Land North of Shenfield

Officers' Meadow, Shenfield

Design Evolution Document

December 2024

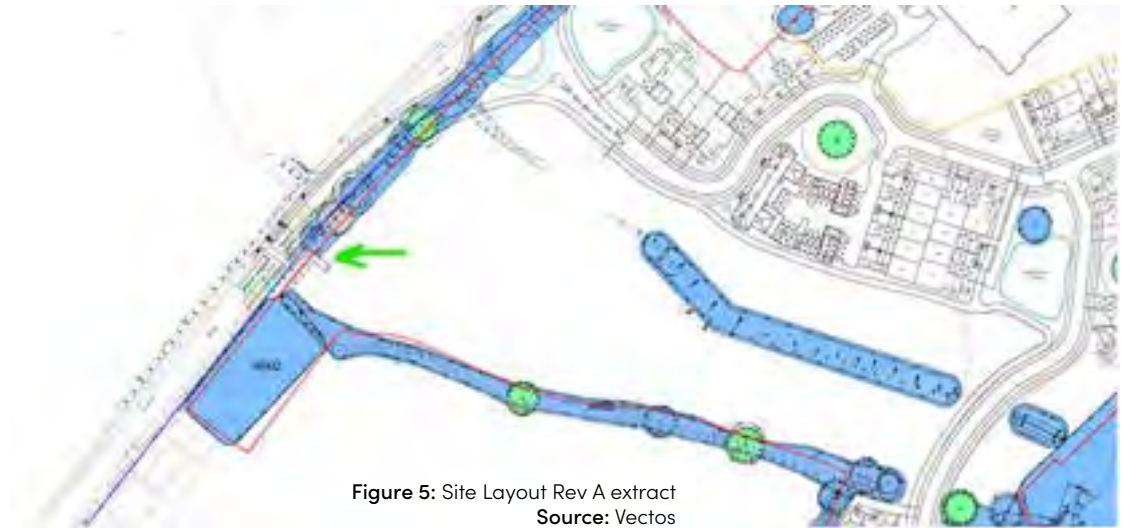
- We are proposing a ped/cycle access here to provide access to the bus stops. I think, but am not sure, Finc are showing a link below which we should connect to the stump.
- Do we need to consider how pick up/drop off will work at the school? Will it be primary or secondary?
- I am not entirely sure what side of the road is the cycleway towards Alexander Lane so we may need to review how cyclist cross where it switches.

I've now shown the pump station and reshaped the basin around it.

I've connected the cycleway to the trunk at Chelmsford Rd on Vectos plan. This resulted in a couple of minor amendments to the cycleway in front of the apartment blocks.

I've shown a dashed purple line where the Cycleway is proposed. This makes the most sense for connecting the school to the rest of the site, connecting the north/south parts of the site and connecting to Redrow's site.

Figure 16: Site Layout Rev P
Source: FINC Architects

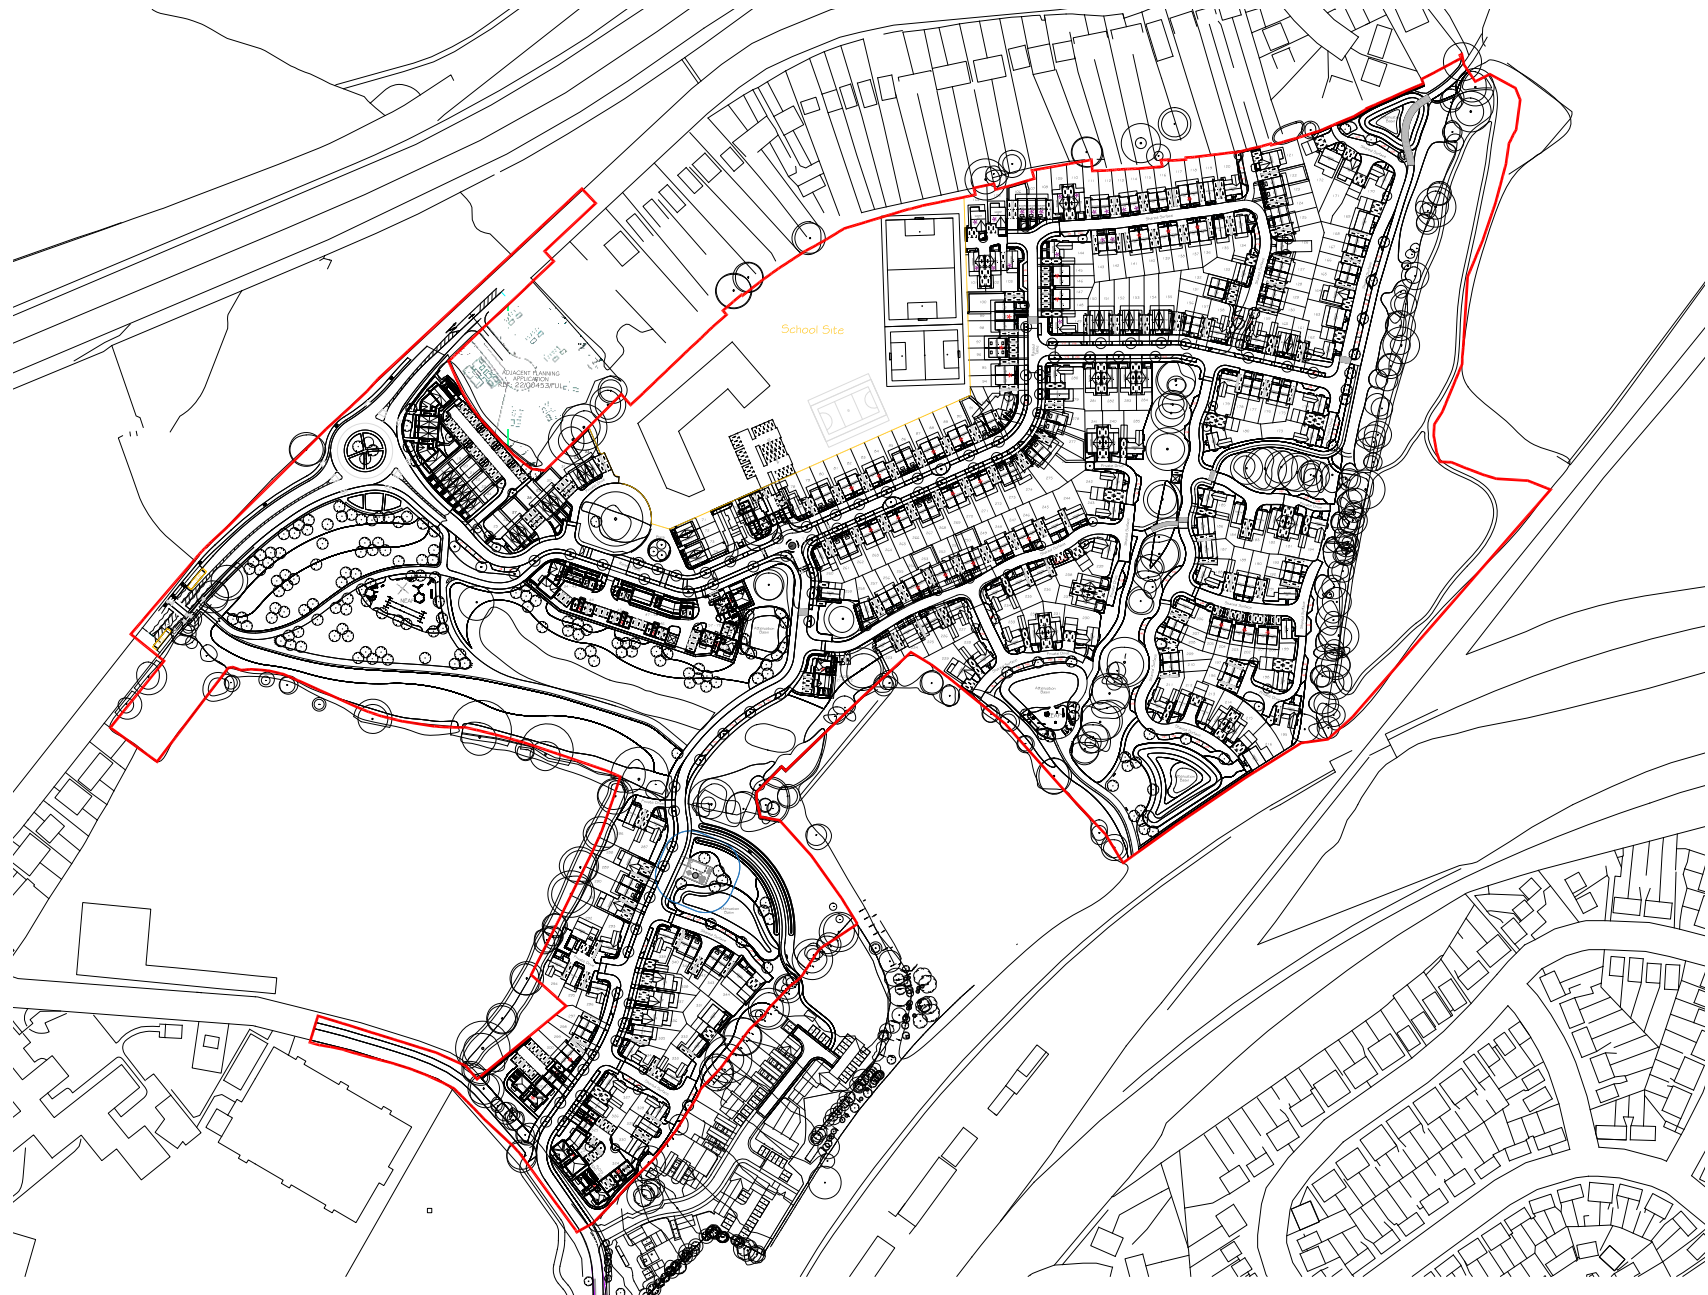
Landscape was missing from the site layout

- Landscape information incorporated into the site layout
